To: <u>Saric, James</u>
Subject: Draft FS Comments

U.S.EPA COMMENTS ON THE

AREA 1 FEASIBILITY STUDY ALLIED PAPER, INC./PORTAGE CREEK/KALAMAZOO RIVER SITE

Figure 1 - Temporal decline in wet-weight PCB and lipid content in Carp fillets from Kalamazoo, Mosel, and D-Avenue sampling stations.

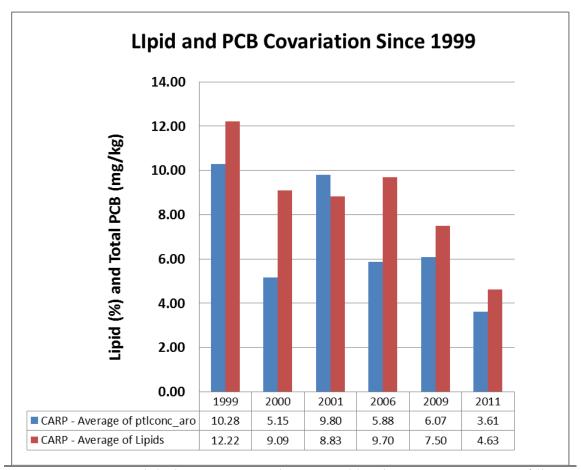
Data evaluations indicate that the trends based on wet-weight PCBs overstate the rate of decline in carp and smallmouth bass tissue samples—_Lipid content was found to explain a significant portion of the PCB decline. Therefore, much of the apparent decay of PCBs in tissue is explained by temporal variation in lipid content (see Figure 1 for carp, below). Extrapolation of wet_weight PCB decay trends requires the assumption that lipid content trends will continue to decline through time as well—_However, it is not possible for lipids to decline below species_specific minimums; and therefore, PCB trend calculations need to consider and compensate for lipid trends—_ASo a reasonable approach for future projections is to simply assume that, over time, lipid content will fluctuate between temporary high or low levels, but generally but centered on some a long—term average lipid value. This may be best estimated from the long—run average lipid content within the monitoring data. For this analysis, all fish tissue data were standardized to a common lipid value given by the average lipid content observed in the data for each species from 1993 through 2011. This The approach provides a long—term exposure trajectories that reflect PCB concentrations associated with this the long—term average lipid

level. The lipid—adjusted values are calculated by regressing log (PCB) on log (lipids), calculating the expected PCB concentration for the selected lipid content, and then adding the regression residuals to the expected PCB values. These values represent a sample of fish tissue values, all of which contain the same lipid content. Theis approach is the mathematical equivalent to selecting fish for analysis with similar lipid levels, and should be used for development of temporal trends in PCB fish tissue concentration.
